April 10, 2001
NUH61B-TNW0104-01

Subject: TN West Review Comments of the Preliminary Certificate of Compliance and Safety Evaluation Report for Standardized NUHOMS® System 61BT DSC Amendment

Comments on the Preliminary NUHOMS[®] CoC (61BT DSC Amendment)

Figure K.1-1
NUHOMS® -61BT DSC Components

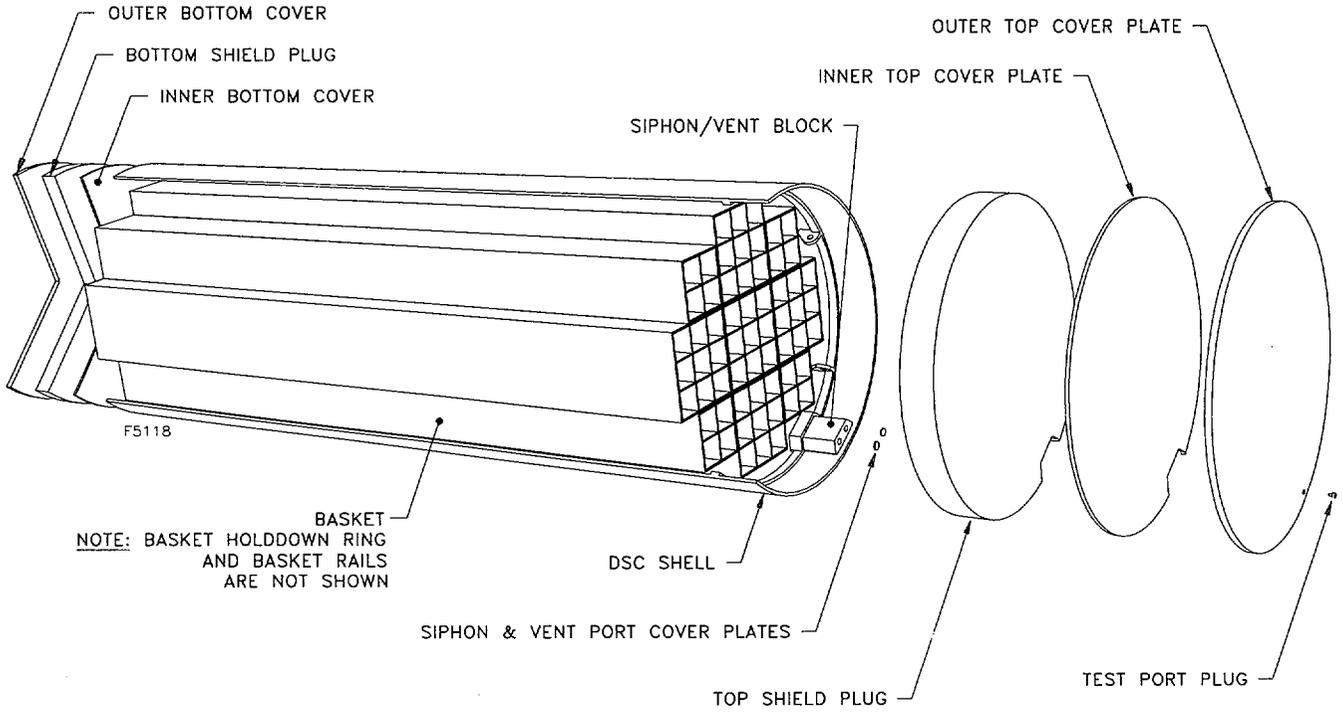
1. Revise Figure 1 to change the term “Vent Port Plug” to “*Test Port Plug*” to be consistent with the drawings included in Chapter K.1.5 of the SAR. A revised version of SAR Figure K.1-1 showing the correct description is included with this submittal.
2. Page 1-1, para 1.1: Revise second sentence to say “*Boral*[®], borated aluminum or boron carbide/aluminum metal matrix composite plates provide criticality control ..”
